[Docket No. 99-NM-22-AD; Amendment 39-11640; AD 2000-05-30]

#### Airworthiness Directives; Boeing Model 747 Series Airplanes

**ACTION:** Final rule.

FIGURE 1

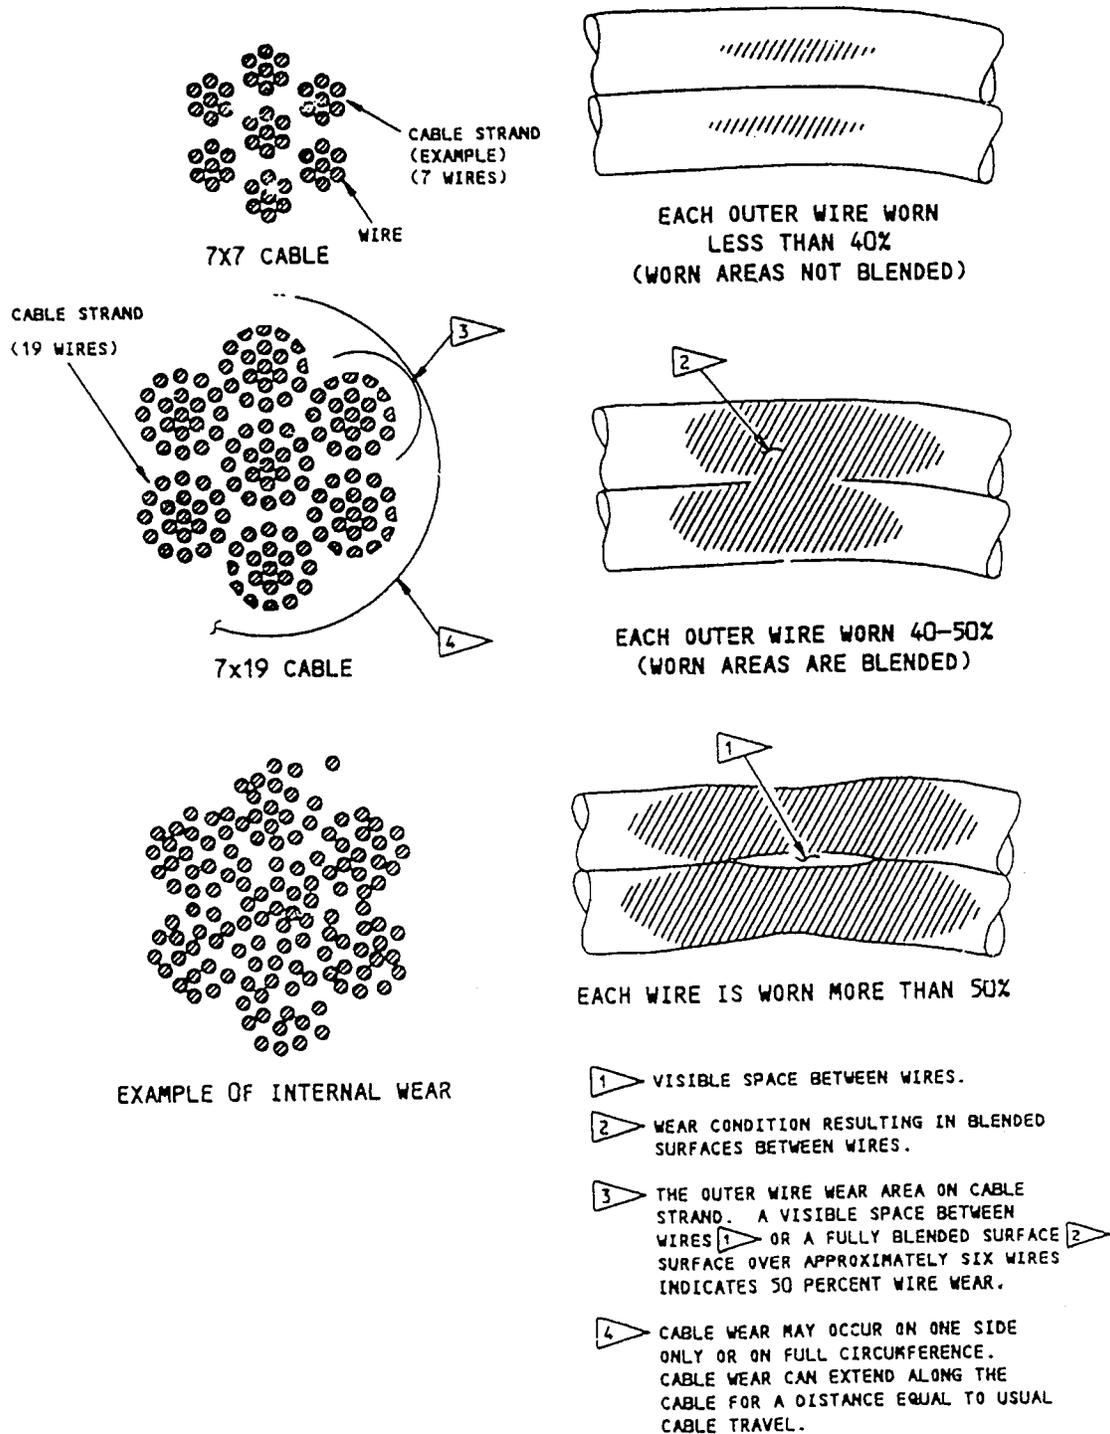
The FAA has revised Figure 1 of Appendix 1 in the final rule to correct the percentage of wear of each outer wire of the thrust control cables as illustrated. The correct percentage (40%) was specified in Appendix 1, Paragraph 2.B.(1) of the proposal. Figure 1 of Appendix 1 in the proposal illustrated, "Each outer wire worn less than 50%." Figure 1 of Appendix 1 in the final rule illustrates "Each outer wire worn less than 40%."

(1) One cable strand had worn wires where one wire cross section is decreased by more than 40 percent (see Figure 1),
